Minutes of the Pre-Bidding Conference for RfQ19/01861 Provision of technical design services for construction works and preliminary costs estimation for the Dinamo Swimming Centre facilities for MIA Project

Ref. no: RfQ19/01861

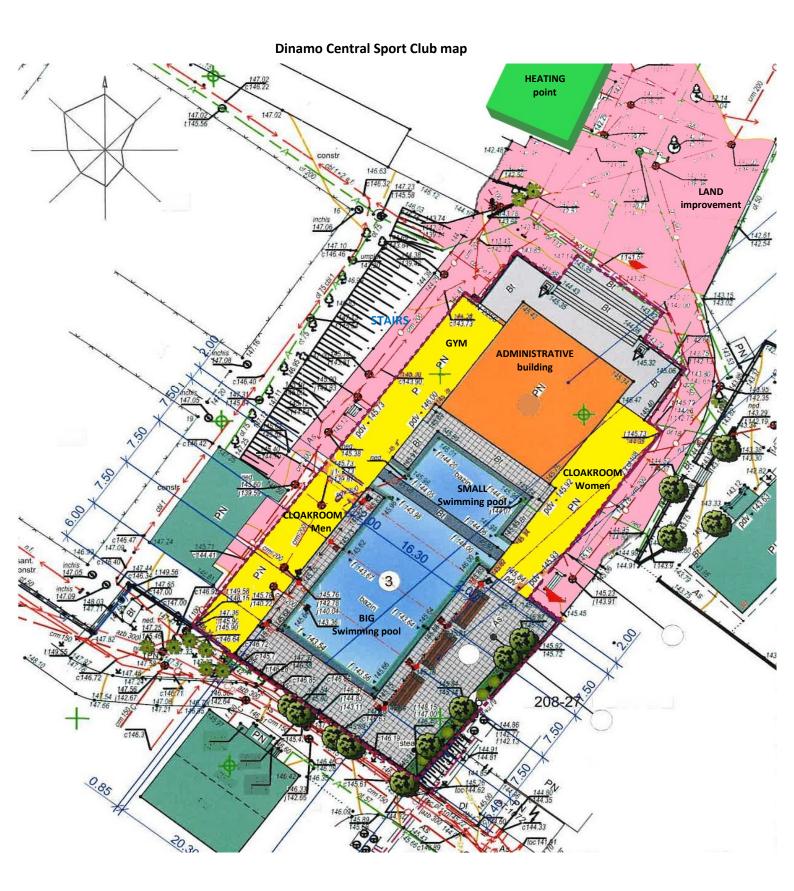
Modernization works for **Stage I** started in September 2018 (scheme below, **are marked with squares**). By now, some of the targeted works for swimming pools were finalized.

The administrative building, according to Dinamo CSC (orange area) must not be demolished but redesigned.

The yellow areas (cloakrooms, bathrooms, gym), orange area (administrative spaces, multifunctional gym, cloakroom), white and pink areas (stairs and land), including the external networks laying from the swimming pools, cloakrooms and central block to the

light green area - thermic point, represent objects for redesign as part of modernization Stage II, under in this tender.
